Flashing 4WD Lights and MIL ON with DTC P277111, P178462 and/or P17AC62

Service Category Vehicle Interior

Section Meter/Gauge/Display

The transfer case breather hose has been updated. Follow the Repair Procedure in this bulletin to address these conditions.

Figure 1. Manual Transmission Breather Hose

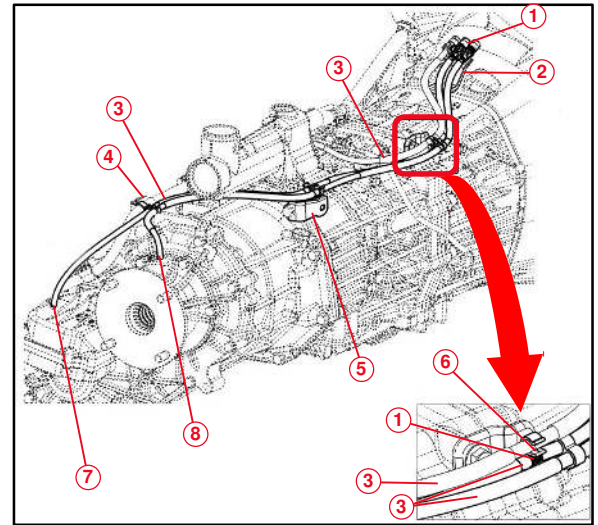
6. Install the NEW breather hose:
 - For manual transmission go to substep A.
 - For automatic transmission go to substep B.
 - For hybrid transmission go to substep C.
- A. For a manual transmission, note the paint mark color on the breather hose is white (Hose Sub-Assy, Transfer Breather 36407-04111).
 - (1) Assemble the breather hose clamp to the transmission bracket.
 - (2) Assemble the breather hose assembly to the transmission breather clamp.
 - (3) Assemble the breather hose clamp to the transfer case bracket.
 - (4) Assemble breather hose to the wire harness clamp.
 - (5) Insert the hose onto the transfer case and actuator tube.

Figure 2. Automatic Transmission Breather Hose

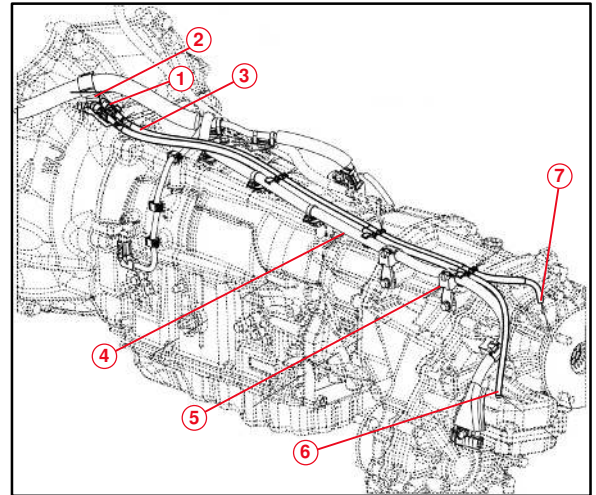
- B. For an automatic transmission, note the paint mark color on the breather hose is yellow (Hose Sub-Assy, Transfer Breather 36407-04121).
- (1) Assemble the breather hose clamp to the wire harness bracket.
 - (2) Assemble the breather hose clamp to the wire harness.
 - (3) Assemble the breather hose clamp to the rear side of the wire harness clamp.
 - (4) Insert the hose onto the transfer case and actuator tube.

Figure 3. Hybrid Transmission Breather Hose

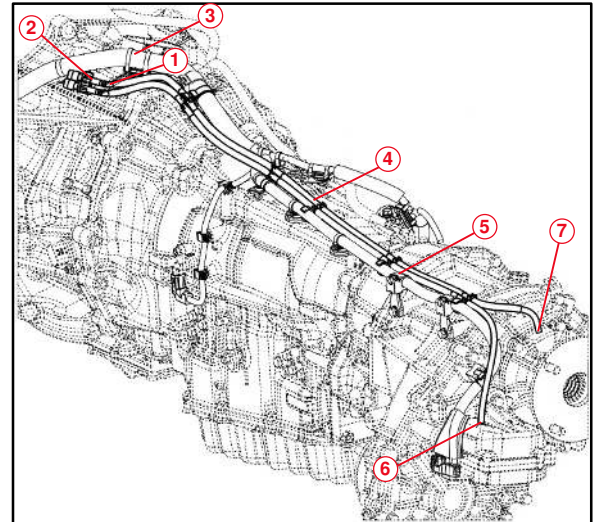
- C. For a hybrid transmission, note the paint mark color on the breather hose is green (Hose Sub-Assy, Transfer Breather 36407-04131).
- (1) Assemble the breather hose clamp to the wire harness bracket.
 - (2) Assemble the breather hose clamp to the wire harness.
 - (3) Assemble the breather hose clamp to the rear side of wire harness clamp.
 - (4) Insert the hose onto the transfer case and actuator tube.
